Title of Change:	Update of NCV7462DQ1R2G datasheet
Effective date:	30 Nov 2022
Contact information:	Contact your local onsemi Sales Office or Jelle.Genne@onsemi.com
Type of notification:	This Product Bulletin is for notification purposes only. onsemi will proceed with implementation of this change upon publication of this Product Bulletin.
Change Category:	Information Only
Change Sub-Category(s):	Datasheet/Product Doc change

Update of NCV7462DQ1R2G datasheet:
 All references to NCV7462DQ0R2G / NCV7462-0 removed from datasheet
 Application diagram updated
 Recommended external components list added
 Watchdog failure behavior description updated

From	To
Datasheet	NCV7462/D, Rev. 6	NCV7462-1/D, Rev. 0

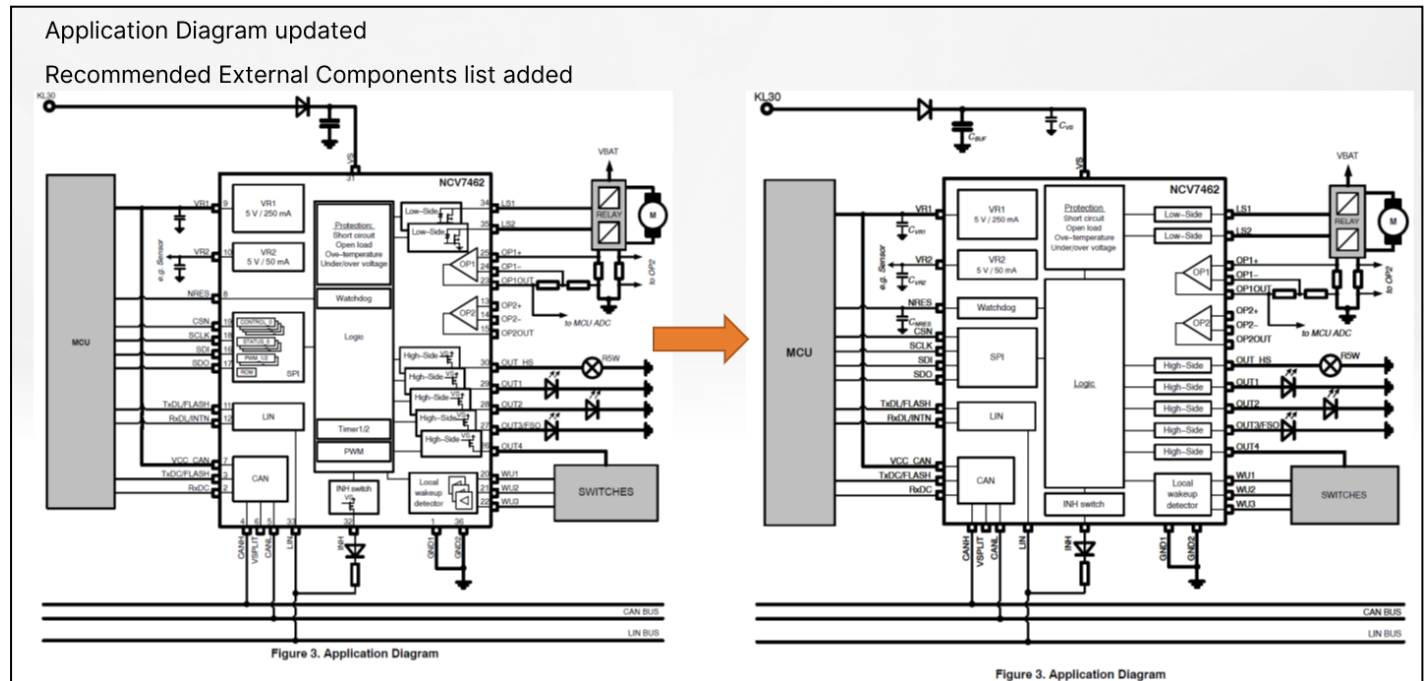
Application Diagram updated
 Recommended External Components list added

Page 37:

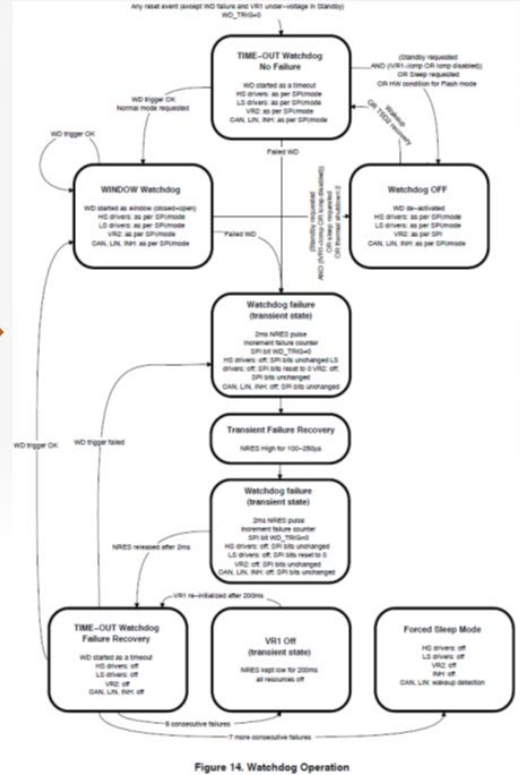
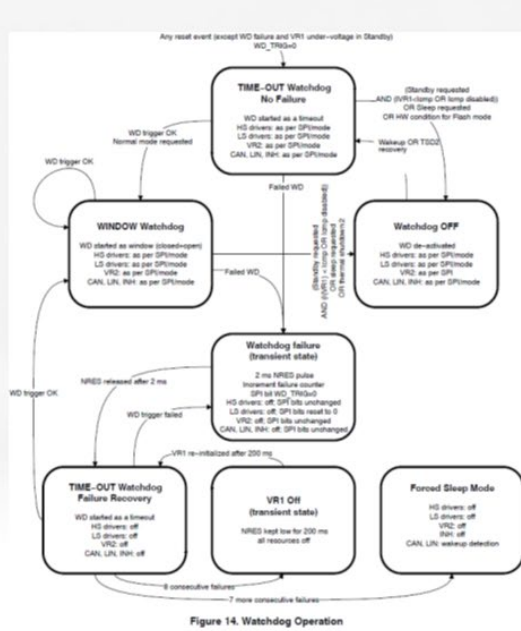
Watchdog failure behavior description updated

Failure: If the watchdog is not triggered correctly (trigger not sent during timeout or open window; or sent during the closed window), reset is generated on pin NRES and the “WD_TRIG” bit is reset to low. After the NRES release, the watchdog always starts in the timeout mode. Watchdog failures are counted and their number can be read from the SPI status registers. After eight watchdog failures in sequence, the VR1 regulator is switched off for 200 ms. In case of seven more watchdog failures, VR1 is completely turned off and the device goes into forced sleep mode until a wake-up occurs (e.g. via the LIN or CAN bus). First successful watchdog trigger resets the failure counter.

Failure: If the watchdog is not triggered correctly (trigger not sent during timeout or open window; or sent during the closed window), two reset pulses are generated on pin NRES and the “WD_TRIG” bit is reset to low. After the **second** NRES release, the watchdog always starts in the timeout mode. **NRES pulses due to watchdog failures are counted** and their number can be read from the SPI status registers. **After four watchdog failures** in sequence, the VR1 regulator is switched off for 200 ms. **In case of three more watchdog failures**, VR1 is completely turned off and the device goes into forced sleep mode until a wake-up occurs (e.g. via the LIN or CAN bus). First successful watchdog trigger resets the failure counter.
